Faulty cast iron pan support rubbers

DESCRIPTION:

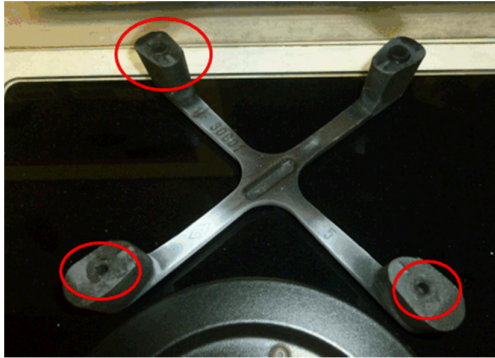
In gas hobs, rubber feet glued to the cast iron pan supports deteriorate and become loose. In order to eliminate the problem, new version of pan supports and rubber feet have been created. As a result, new type of pan supports have threaded larger holes to facilitate the insertion of the rubber feet without any glue.

In case of pan support damage or rubber feet damage, it is possible to order new version of pan supports. New pan supports are compatible with old versions and additionally equipped with new high performance rubber feet.
